**86 Quirk Street, Dee Why**  
**DA2020/0838**

**86 Quirk Street, Dee Why  
DA2020/0838**

**Demolition of existing dwelling and construction of new primary and secondary dwellings  
and a new pool.**

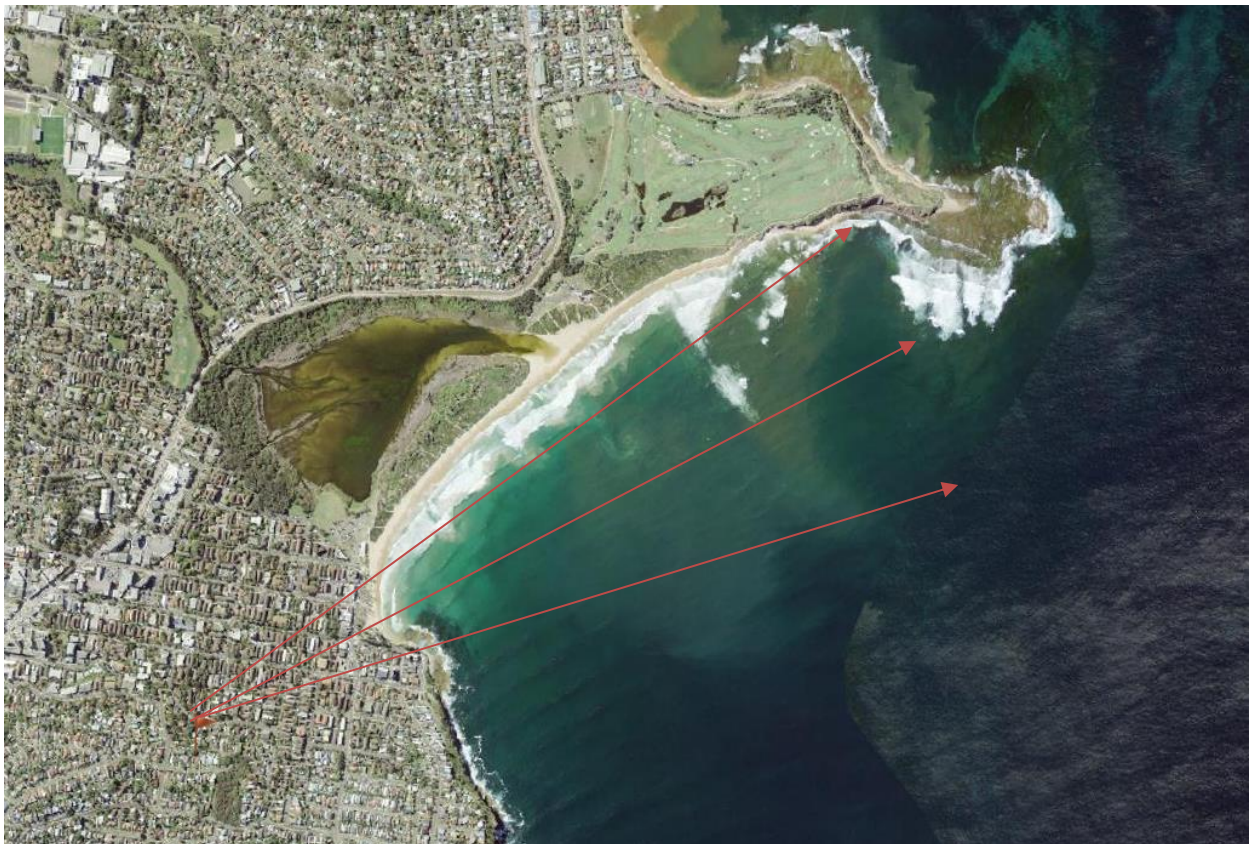
The existing views from 84 Quirk Street which will be affected are highly valuable views, iconic and whole views of the water and land interface and Beach and Long Reef Headland. See the images below taken from the living room, dining room, kitchen, bedroom and outdoor space. Height poles can be seen on the boundary and marked in red by stars.

The key view loss of greatest concern is from the primary living area, kitchen and master bedroom. This highly valuable whole view of the land/ water interface and iconic Dee Why Headland, in addition to a large area of the ocean and the horizon, will be obliterated from these key spaces and the other outdoor areas of the dwelling. The view to the sunrise over the ocean is a key feature for this dwelling and this would be lost from the key living spaces and bedroom as a result of the neighbouring development. The loss of these views from key living spaces is severe, unreasonable, unnecessary and does not represent the principle of view sharing.
